**Re: Revised Traffic and Parking Assessment
3 Clyde Street, Batemans Bay**

The purpose of this letter is to provide additional information in response to traffic and parking issues raised in submissions to the Department of Planning collected during the exhibition of the proposal. Submissions were received from the NSW Roads and Traffic Authority, Eurobodalla Council and a member of the public.

CLYDE RIVER MOTOR INN

Figure 3

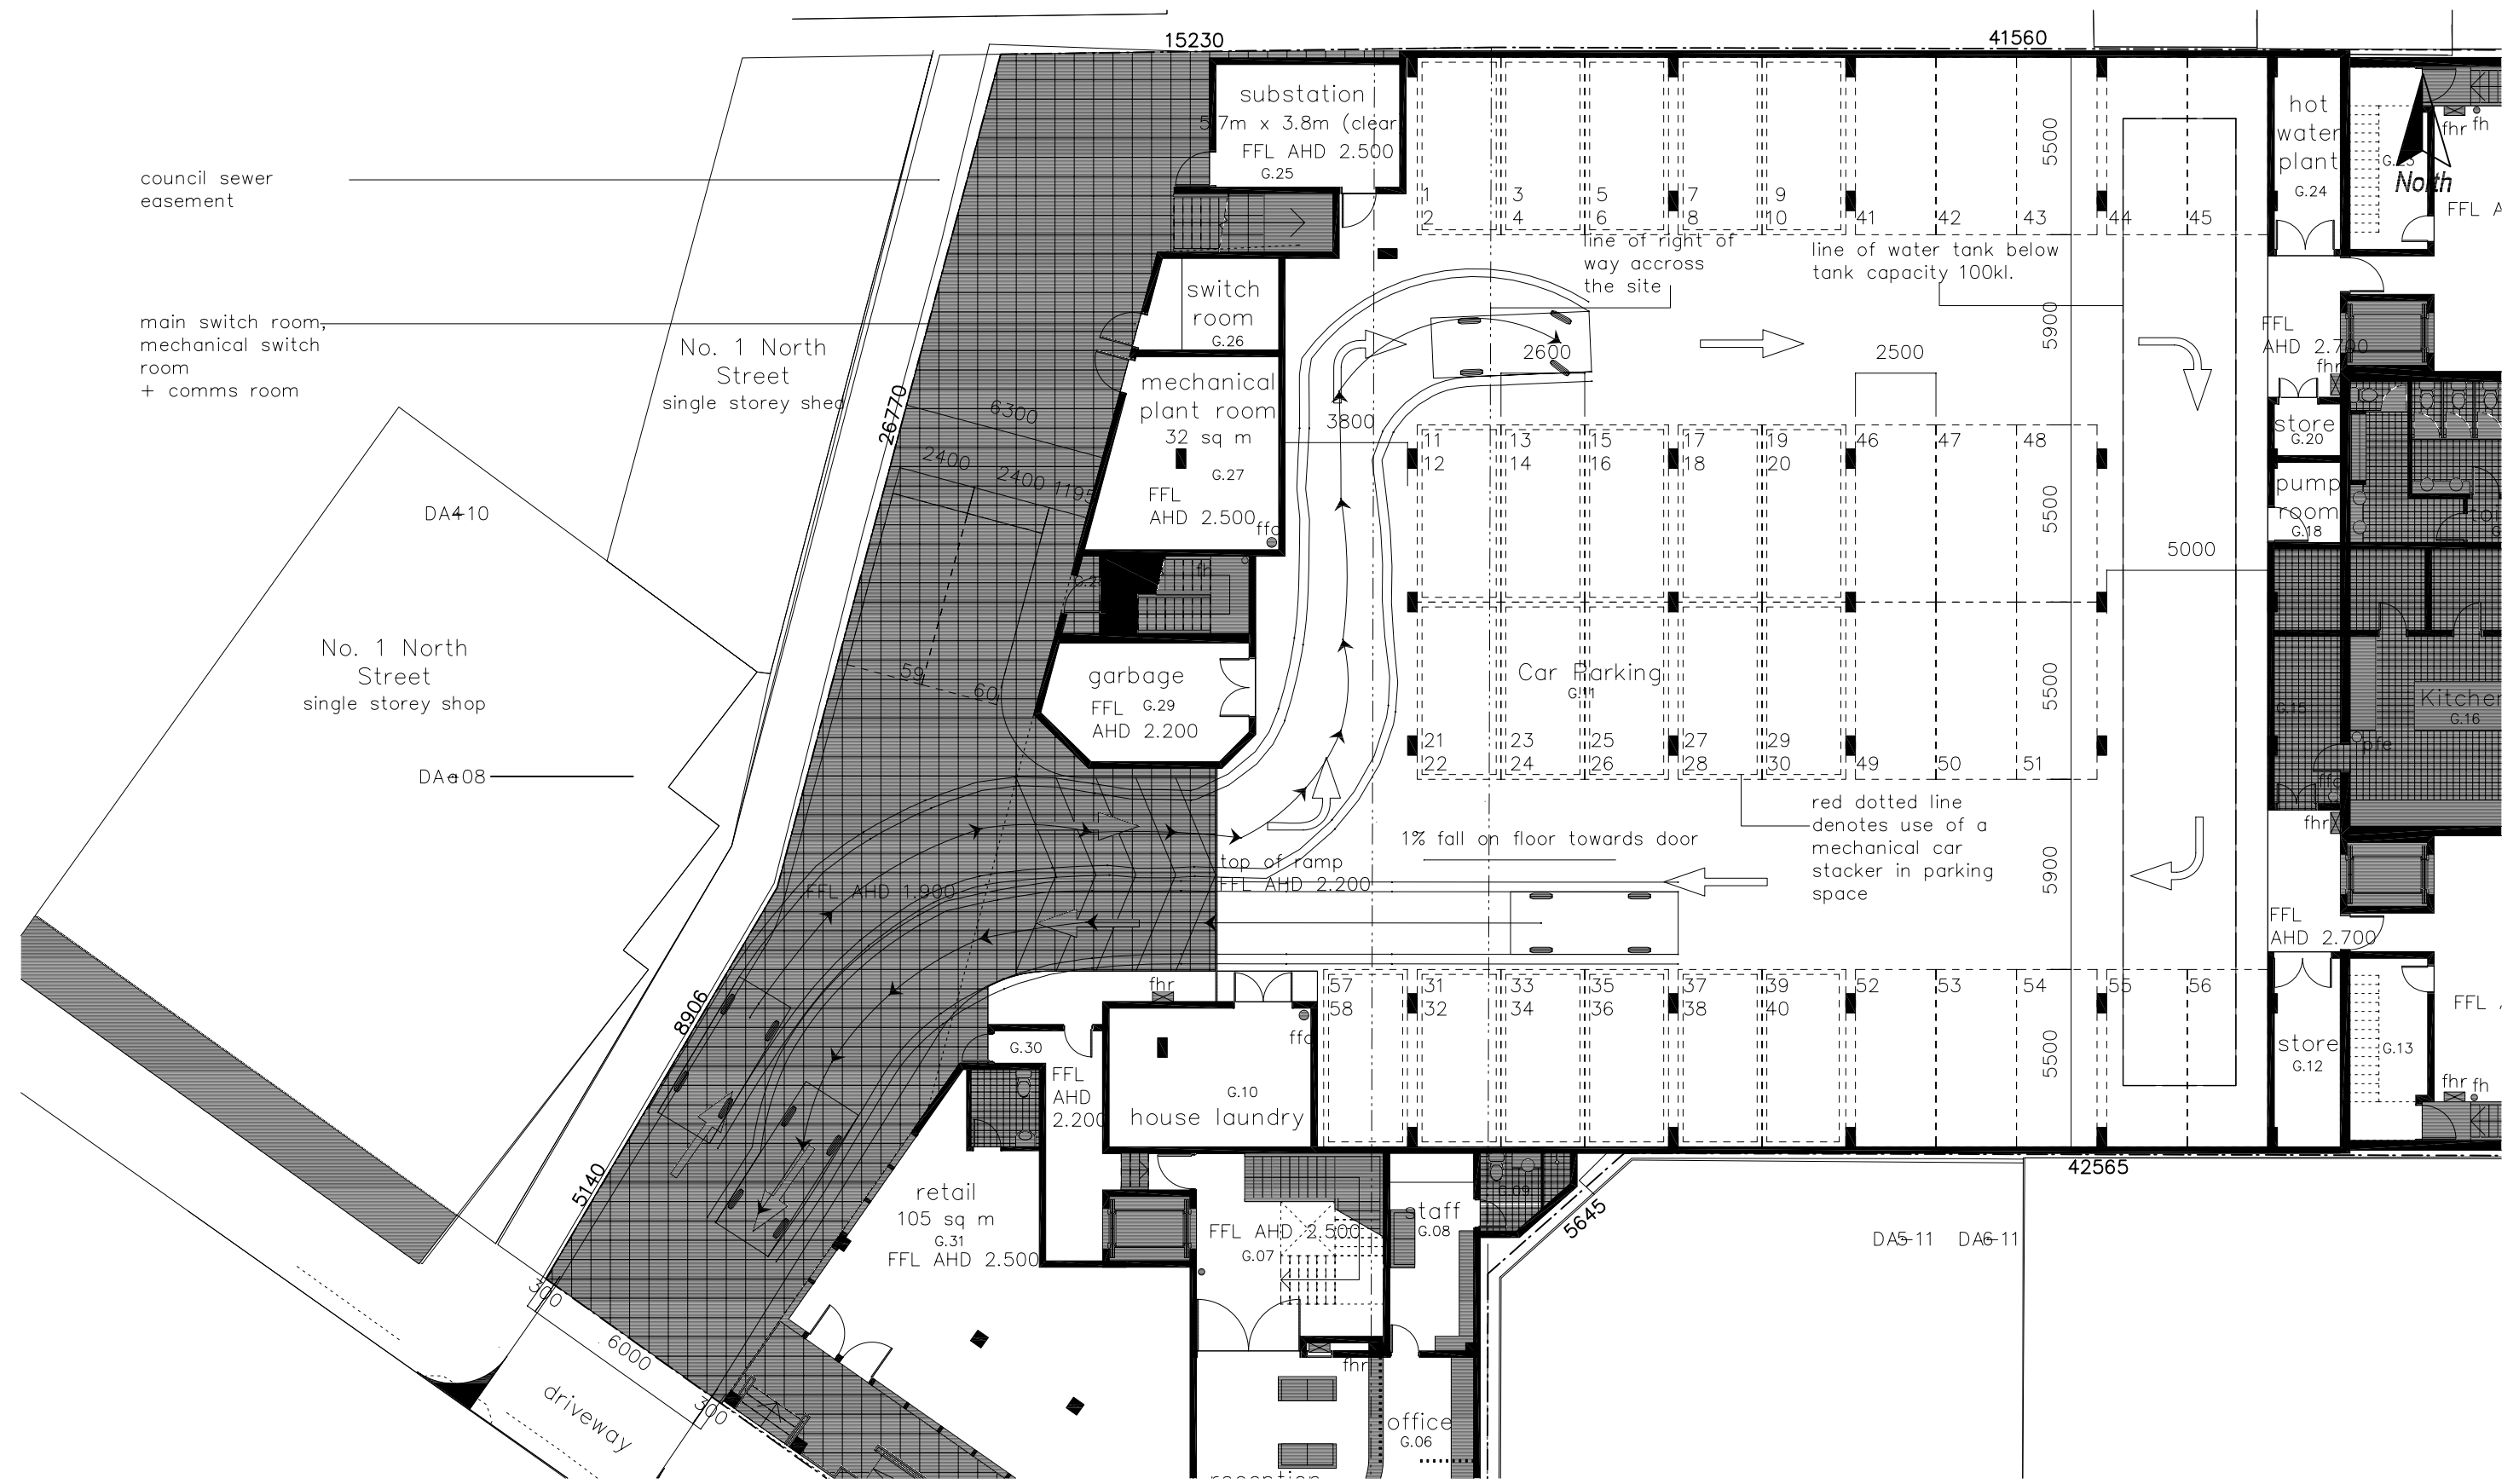
“From Figures 2 and 4, it appears that simultaneous entry and exit on the driveway will be tight. Please clarify this especially given that the valet system will be used for the serviced apartments only.”

The Australian Standard suggests that an 85th and 99th percentile vehicle should be able to pass where aisles intersect, on curved sections of ramp or where vehicle turning is required. We have tested an 85th and 99th percentile vehicle passing each other at the car park entrance. These turning paths are shown in **Figure 3** attached. From **Figure 3** it can be seen that there is adequate width for these two vehicles to pass concurrently. Therefore the proposed car park entry width and approach driveway complies with the Australian Standard and is considered satisfactory.

Figure 4

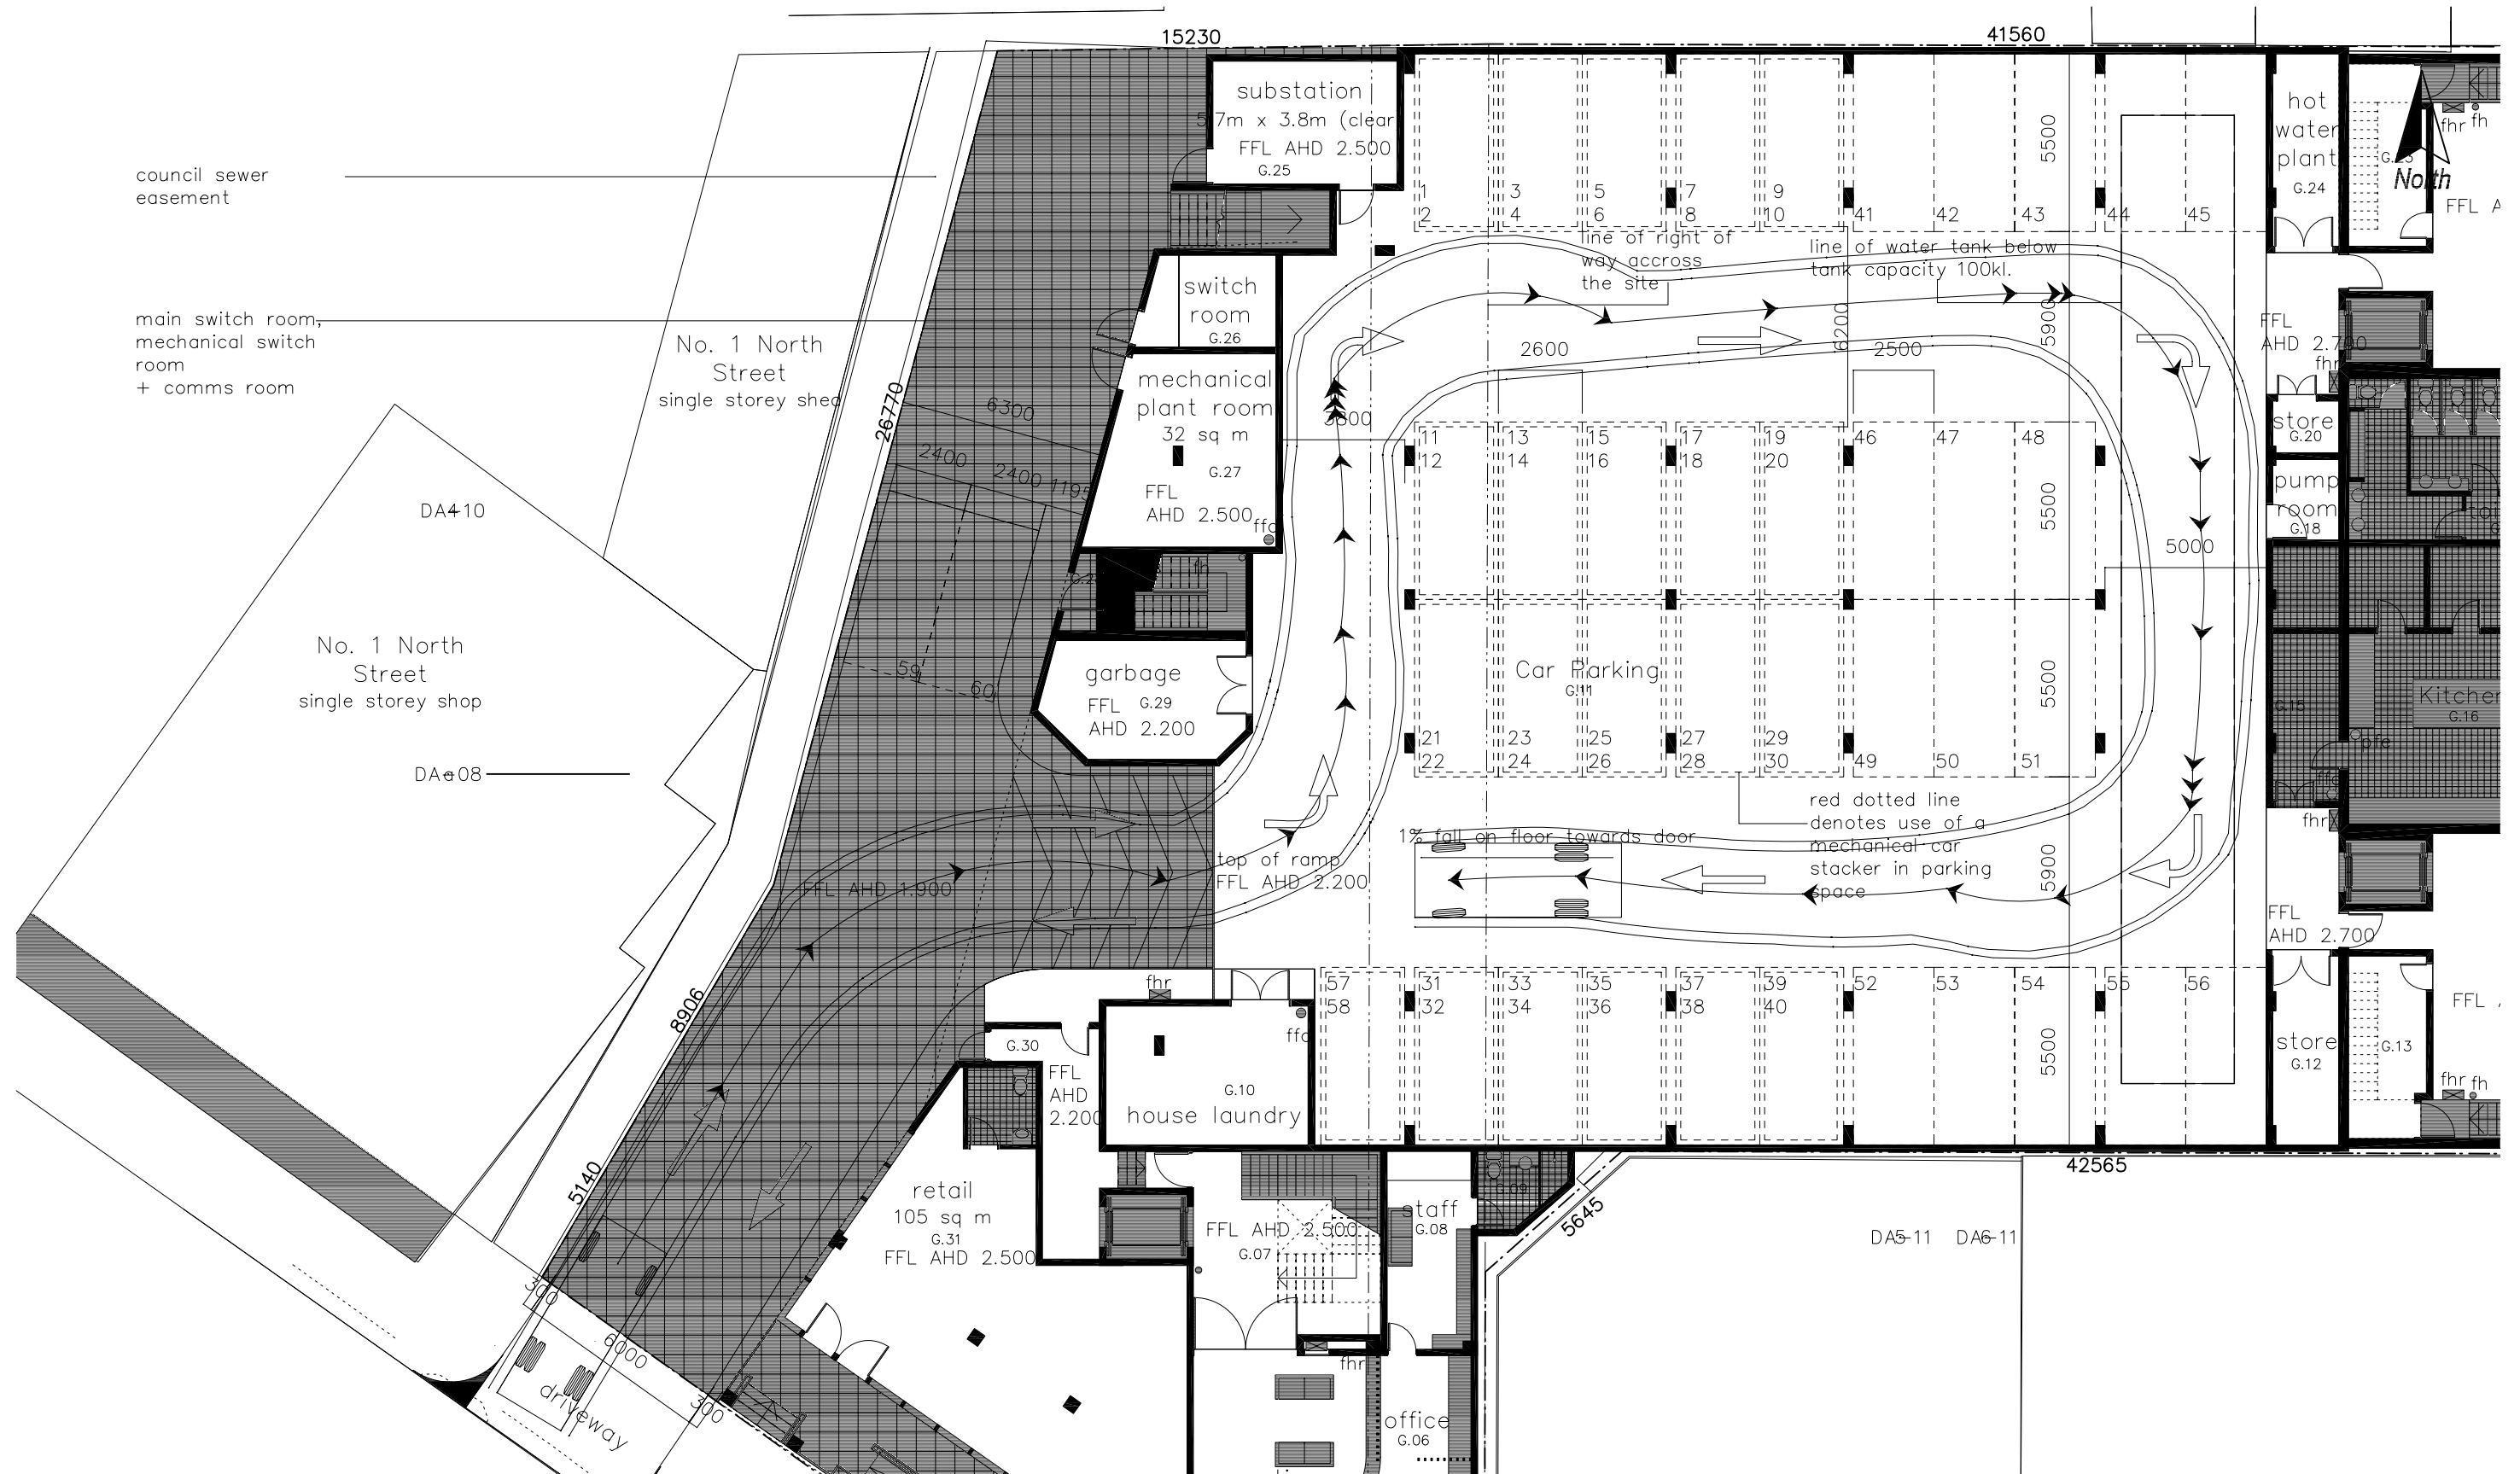
"Para 2: Figures 2 - 4 appear to indicate an obstruction (adjacent to spaces 11/12, 21/22). Please clarify adequacy of swept paths."

It is noted that a waste vehicle which has a capacity of 4.5m² to 7m³ would be typically 2.4m high and require an operating height clearance of 2,780mm. The overall length of such a vehicle including the compactor overhang would be 6.4m. We have tested a 6.4m Small Rigid Truck entering and exiting the car park. This turning path is shown in **Figure 4** attached. As the height clearance outside the garbage room would be 3.5m and the car park can accommodate a 6.4m long truck travelling through it, the design of the car park is considered suitable for a small 4.5m³ – 7.0m³ rear loading waste vehicle to enter and exit in a forward direction.

As stated above, the swept path of a 6.4m Small Rigid Truck has been prepared and overlayed onto the revised car park design. The manoeuvring space within the car park can accommodate this vehicle type which is expected to be the largest vehicle which would access the car park. The proposed layout of the car park is accordingly considered satisfactory.
